**HISTORIC LANDMARK COMMISSION  
STAFF REPORT**

**Loewen Addition  
Major & Minor Alterations  
PLNHLC2011-00214  
545 E 900 S  
August 4, 2011**

Figure 1: Photo of the house from 545 East 900 South in 1905 representing the original character of the house as designed.

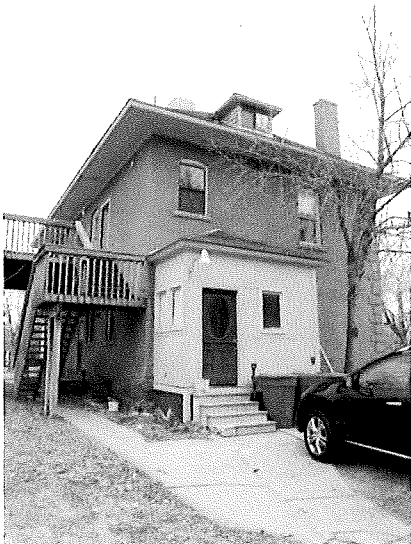
- A. **4-foot Picket Fence-perimeter Fence:** A wooden picket fence outlining the perimeter of the front and corner side yard. The proposed picket fence would be a reproduction of a fence shown in a photo dated approximately 1905. The proposed height is four feet, with 2"x 2" pickets with 4" spacing, and a lower 2"x4" upper and lower rails. The design also includes acorn style finials to provide decorative detailing. The fence height measured from existing grade is four feet. (See Fence A description on Page 1, Site Plan, and photoshop visual)

North Elevation  
1/4" = 1'-0"

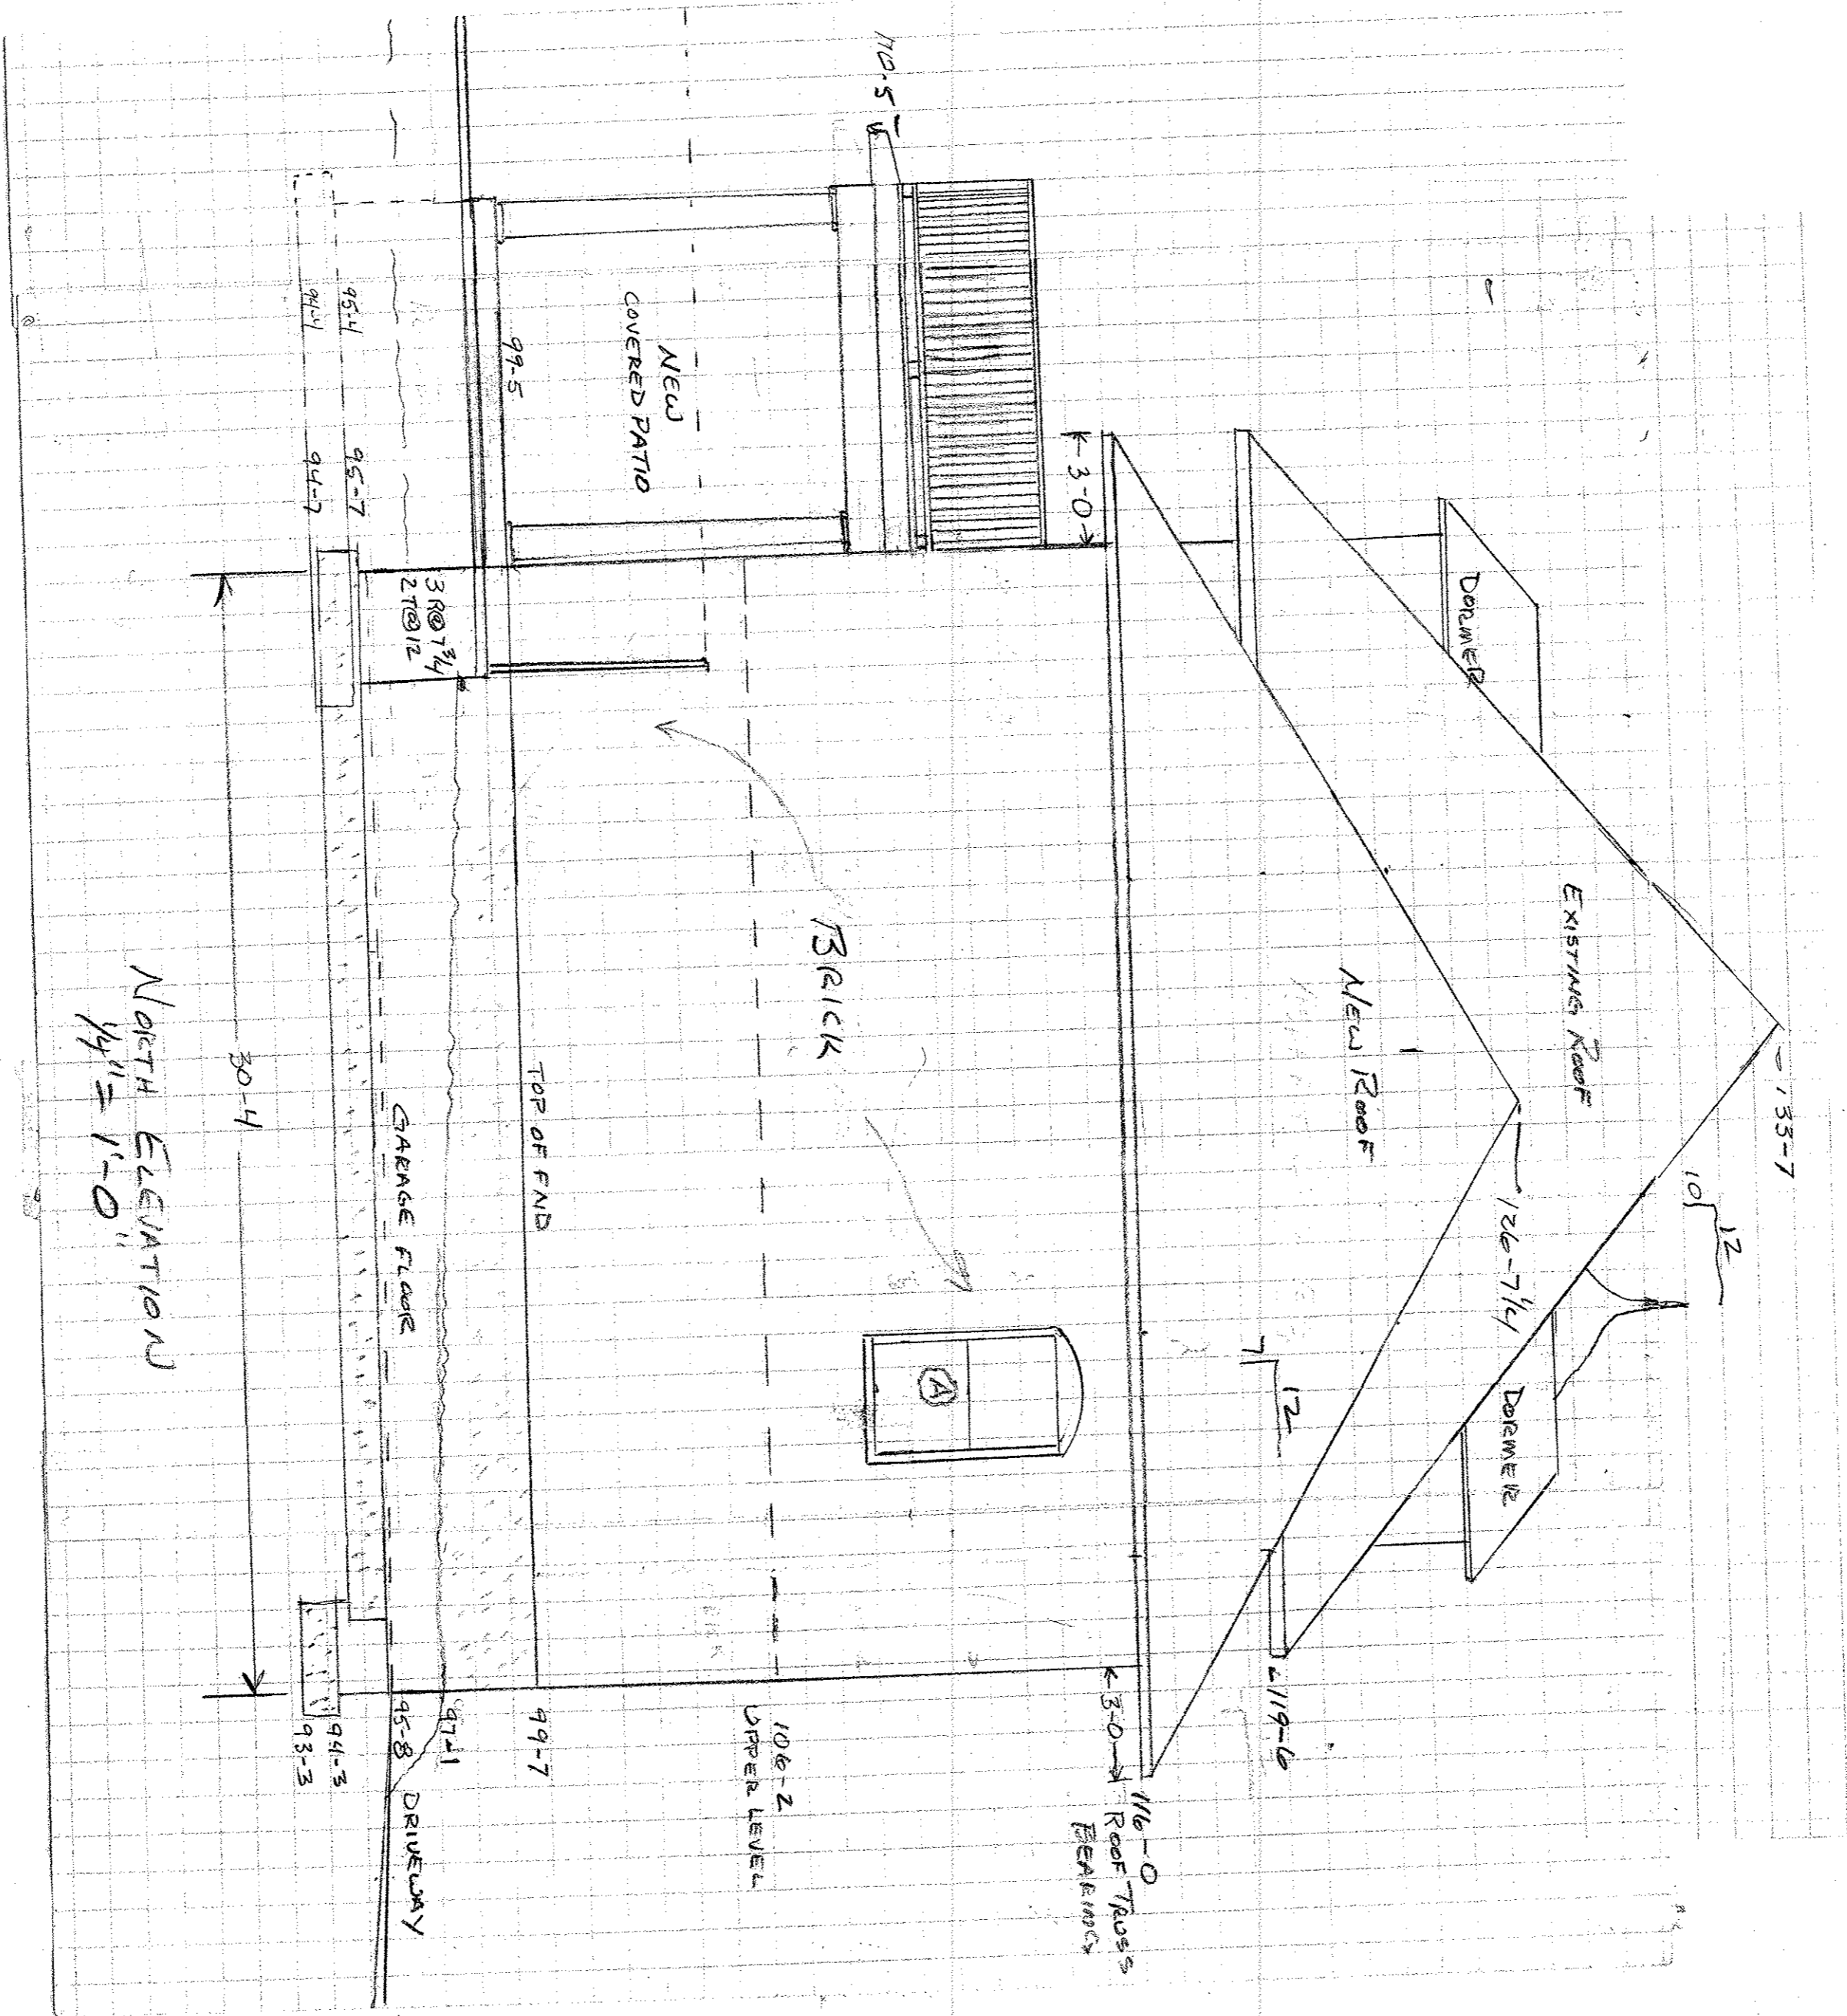
The garage addition is proposed to be approximately 31 feet three inches in height, exceeding the height allowed in the zone (30') by approximately one foot three inches (1'3"). The applicant has provided the building height of each home along Park Street and 900 South (rounded to the nearest foot). The average height of homes along the eastern block face of Park Street is approximately twenty-six feet ten inches (26'10"). The average height of homes on the western block face of Park Street is twenty-three feet seven inches (23'7"). The location and scale of the garage addition would most impact views and the historical context of a pedestrian environment along Park Street. The addition is approximately 4'5" higher than the average building height on the block face.

**Findings:** The proposed garage addition exceeds the height allowed in the RMF-30 Zone by one foot three inches (1'3"), and is not appropriate or subordinate to the principal structure, given the location and size. Staff finds that the addition is not compatible in size and scale with the main building even though it is approximately five feet less in height than the principal structure.

Building Height Computed  
West Elevation = 31'-3/4"  
North Elevation = 28'-11/8"  
East Elevation = 27'-11/8"  
Total Addition = 29'-5/8" Hgt.  
30' Maximum Allowed

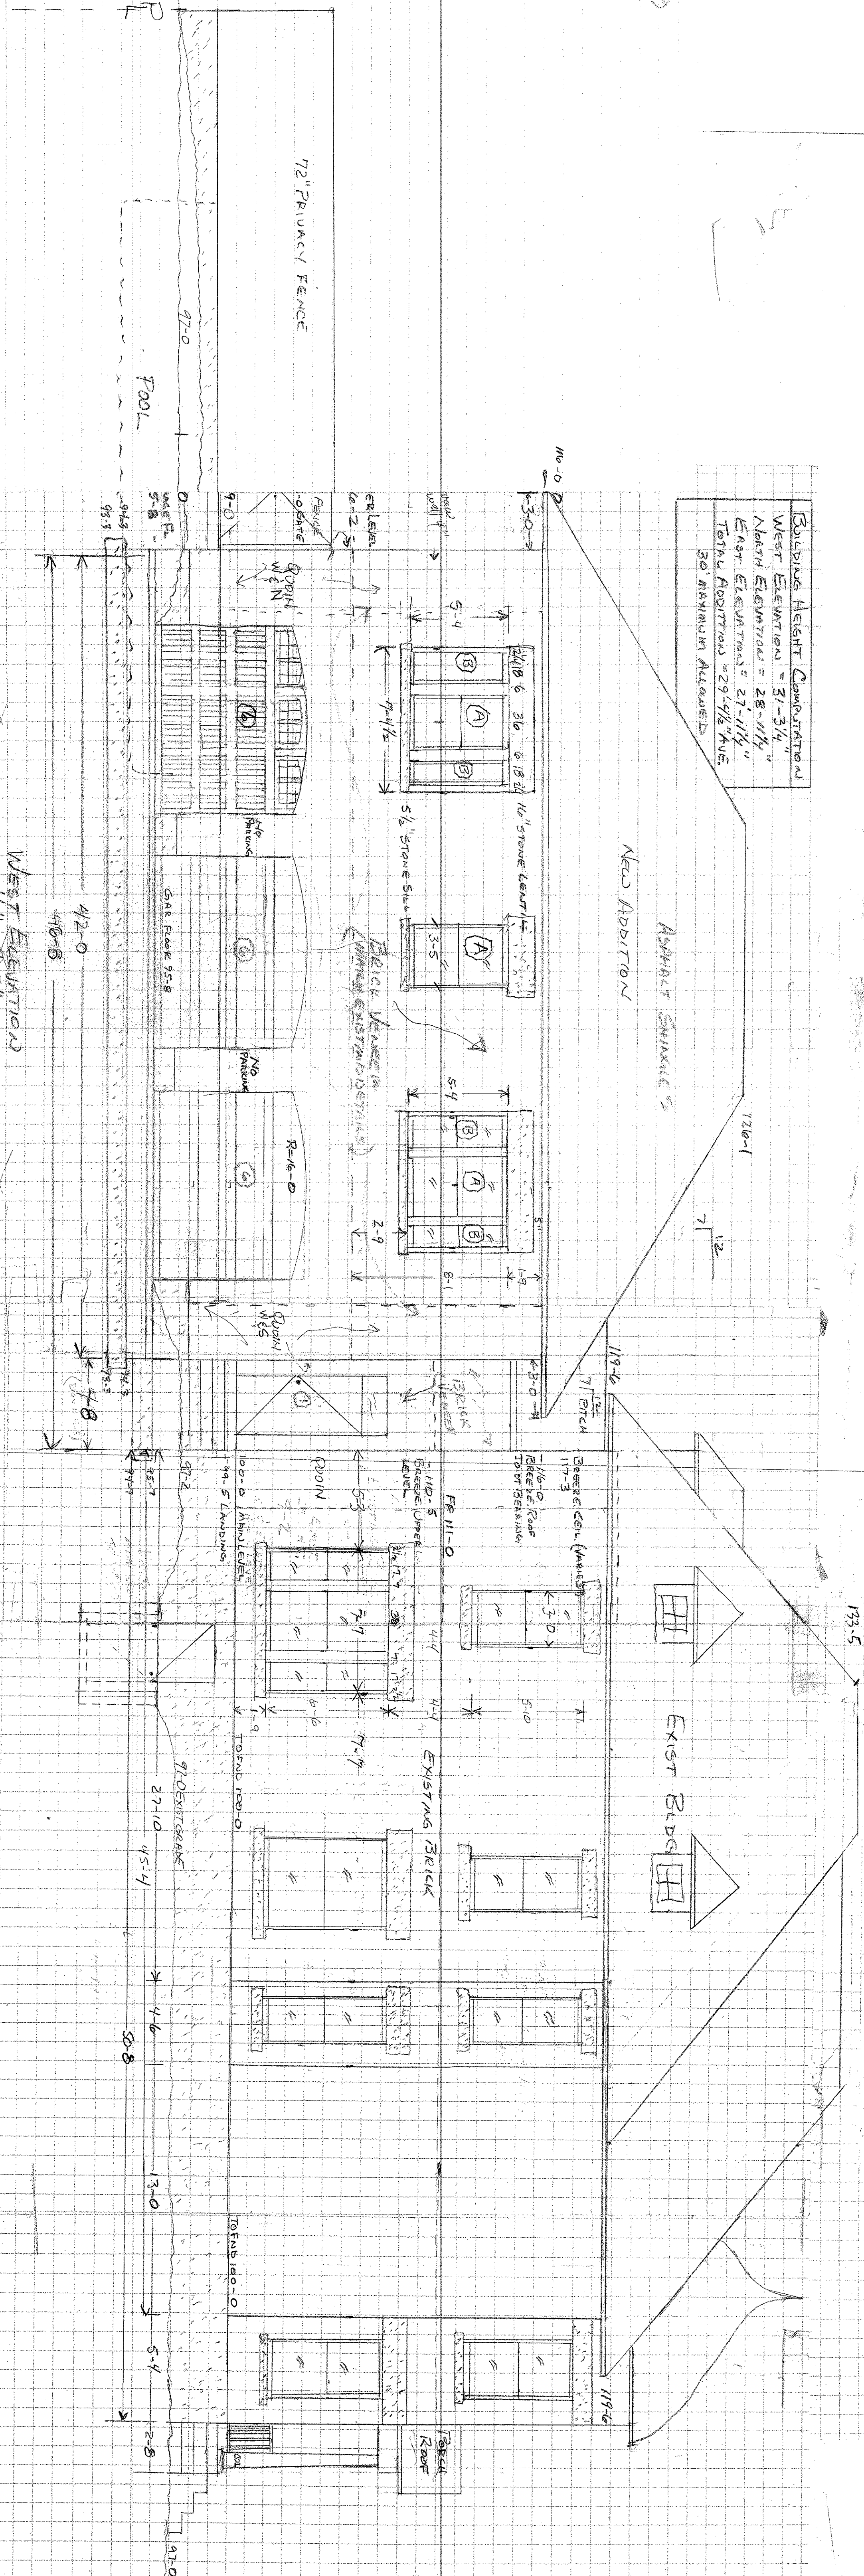
The HLC has the authority to determine if the proposed height is appropriate and decide to approve or deny requests for additional building height. The applicant prepared a block face analysis which is attached to the staff report (see Plan Page 8).
